737

Service Bulletin

Number: 737-78-1106
Original Issue: September 01, 2023
Revision 1: May 23, 2024
ATA System: 7811

SUBJECT: EXHAUST - Turbine Exhaust System - Engine Primary Exhaust Nozzle Change

**FIGURE 4: PRIMARY EXHAUST NOZZLE - UPPER RIGHT BRIDGE BRACKET - PREPARATION
(SHEET 1 OF 14)**

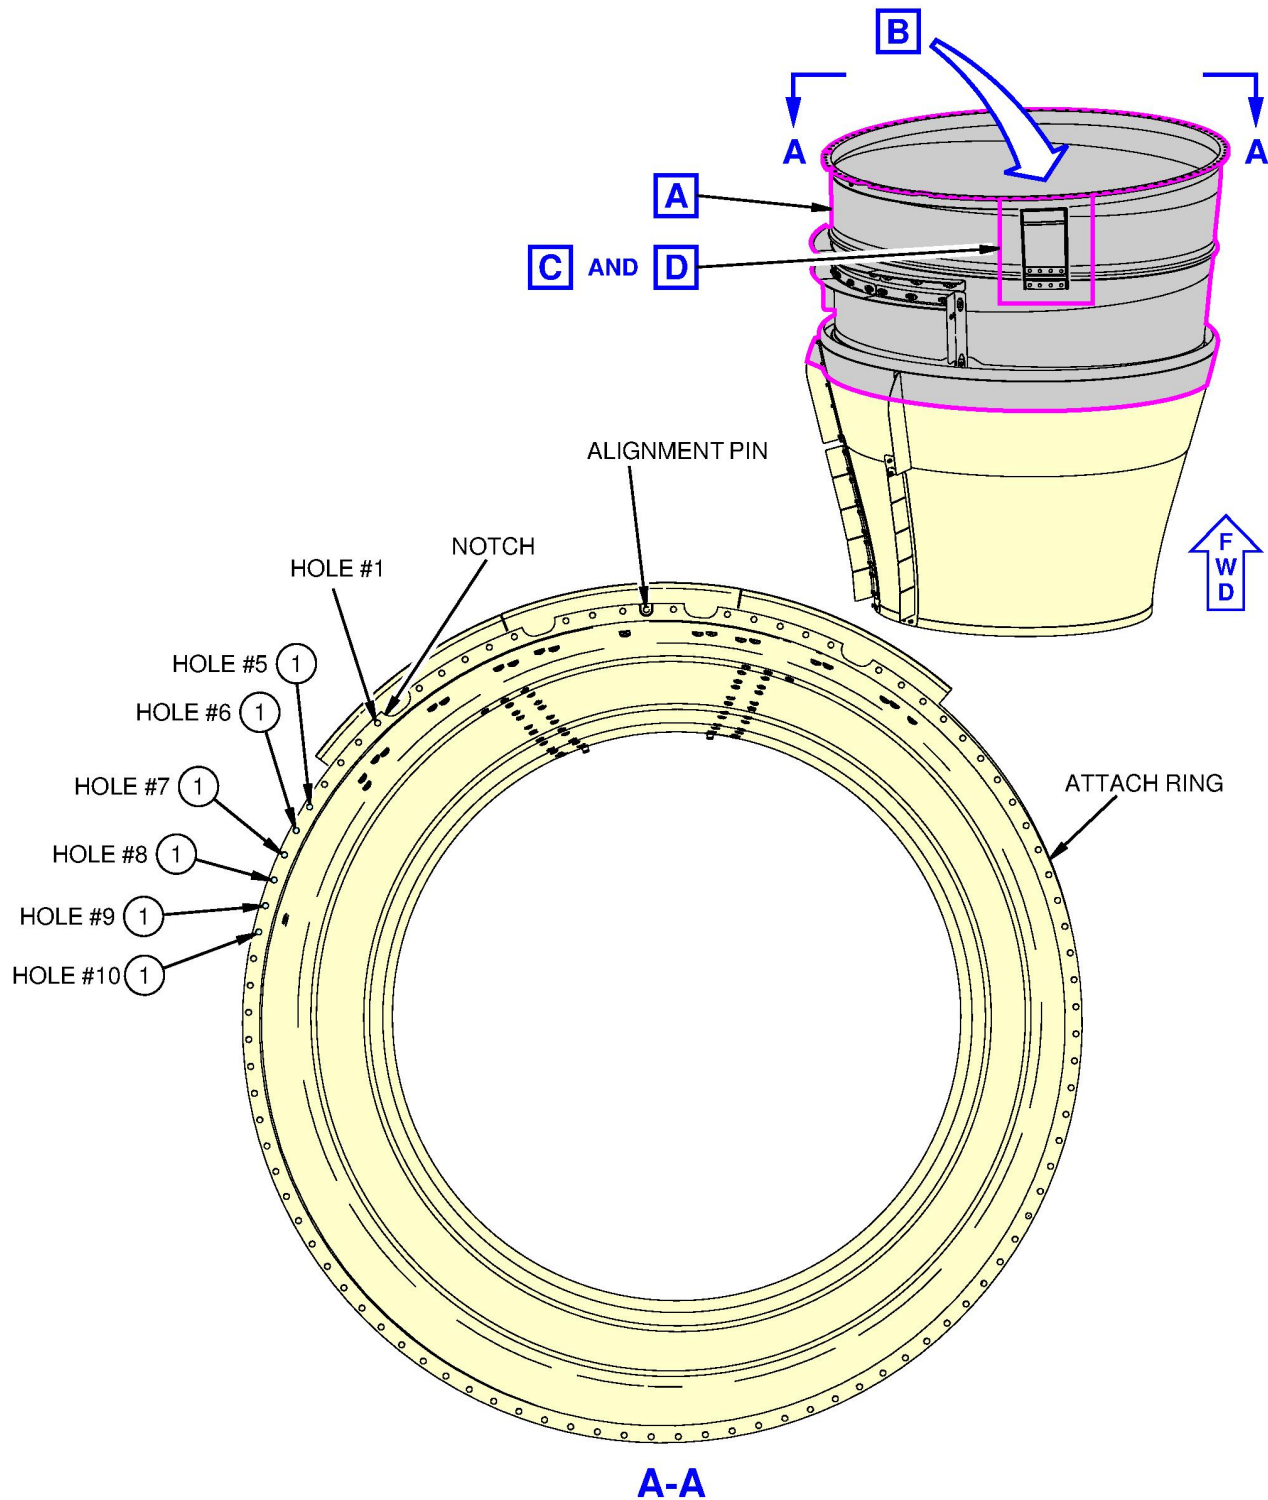
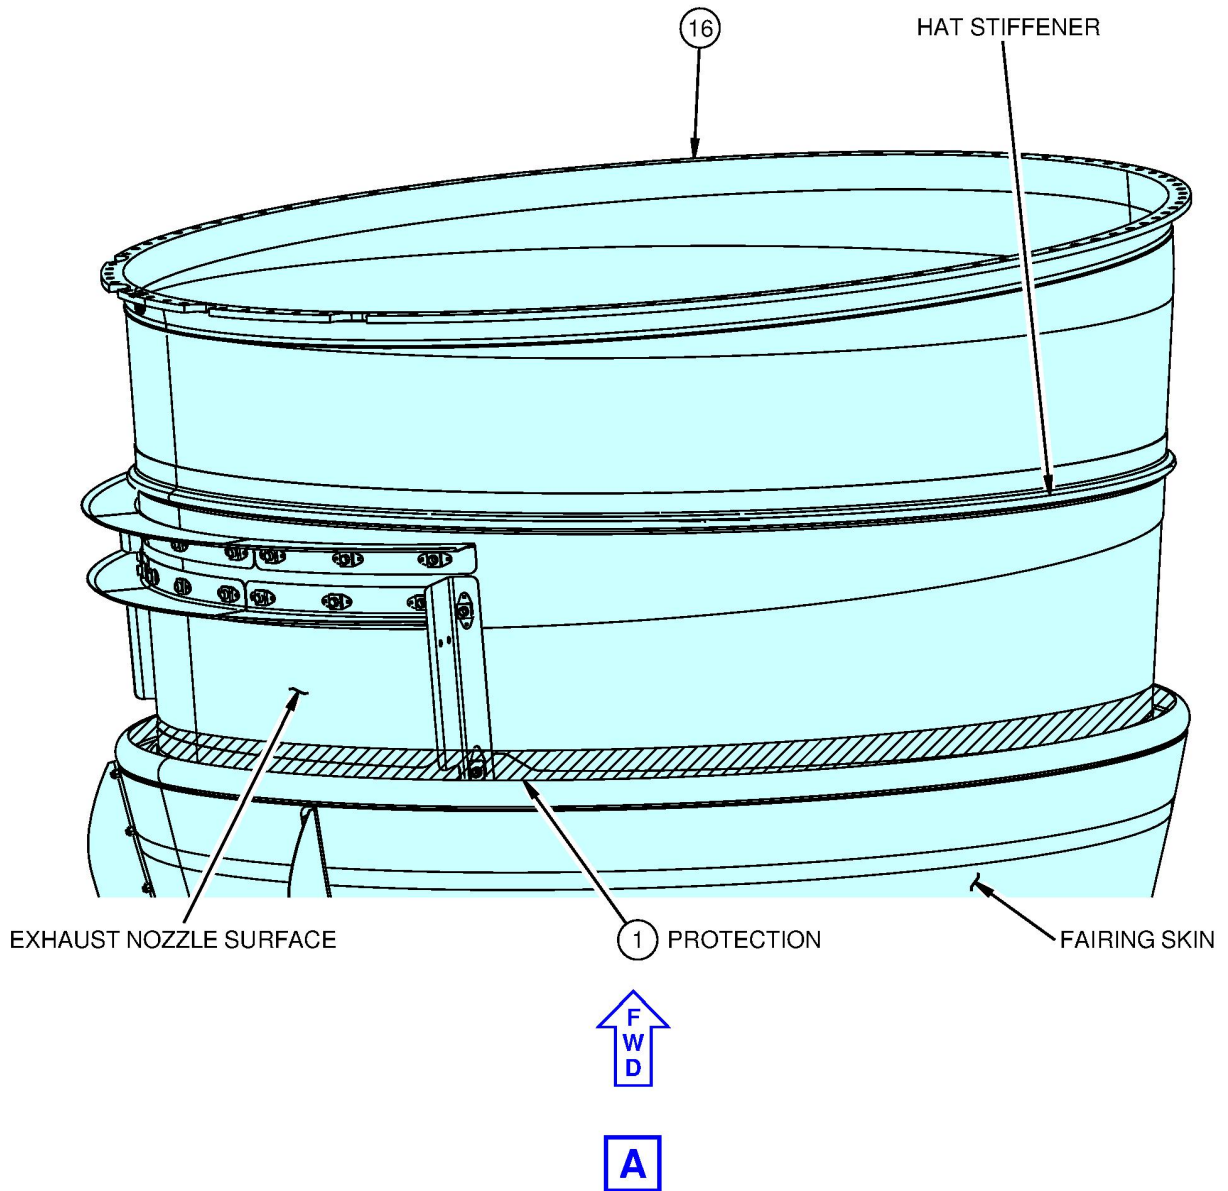
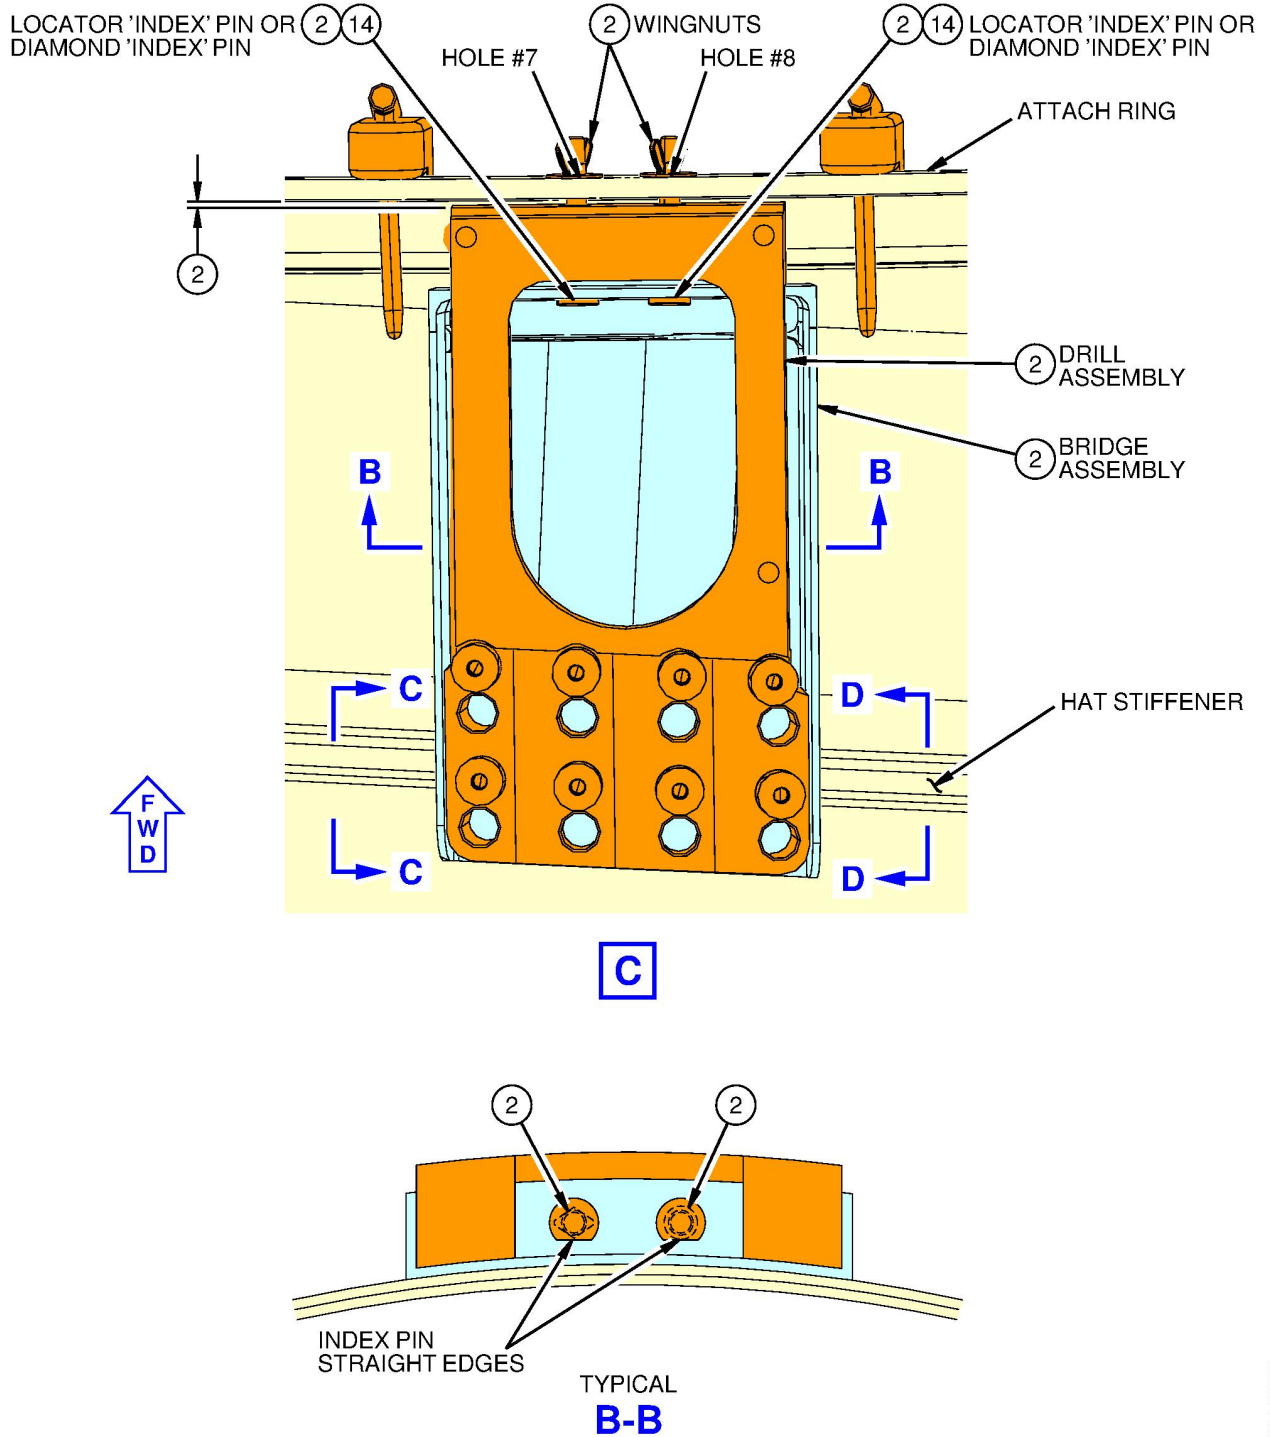
- In Accomplishment Instructions, General Information, changed Note 1.
- In Work Instructions, revised Airworthiness Limitations (AWLs) information.
- In Work Instructions, Figure 4, changed illustration to change location of Alignment Pin.
- In Work Instructions, Figure 11, changed illustration to show cross section of Self-Locking Nut,
- In Work Instructions, Figure 11, changed steps 1 and 2 to call out Self-Locking Nut.
